GeoSolve Ref: 240480.03 V3
19 March 2026

Otago Regional Council
Phillip Laing House
Dunedin 9016
Attention: Shay McDonald

Revised Surface Water & River Engineering Assessment Memo Bendigo-Ophir Gold Project Fast-Track Application Assessment

Figure 1: Site plan and proposed features as per EGL's response

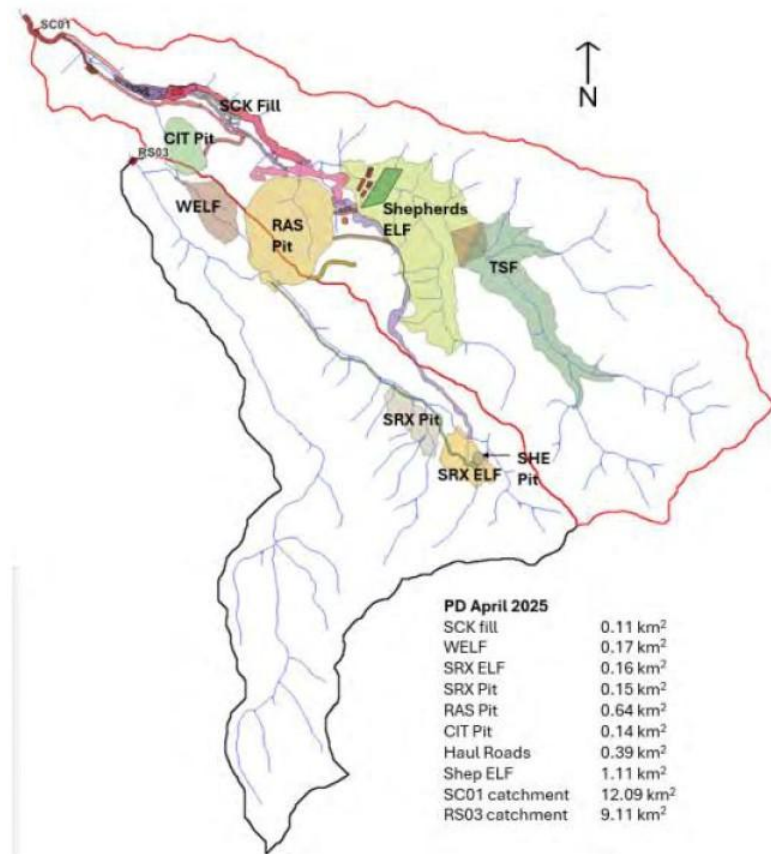
Overall adequacy of response is considered to be that both Question 4 and Question 6 are partially answered, however there are omissions from both of the answers, particularly Question 6. Some of the critical omissions are:

- No overtopping risk assessment (e.g. back-scour and channel re-routing potential)
- No confirmation channel passes design flood in all locations without overtopping
- No detail on how potential aggradation will be mitigated to maintain flow capacity

- Missing alignment geometry and lengths
- Construction sequencing not specified
- No hydraulic profile outputs
- No detailed design drawings

This matter is not yet agreed and further information is required as per the (non-exhaustive) table and bullet points above.
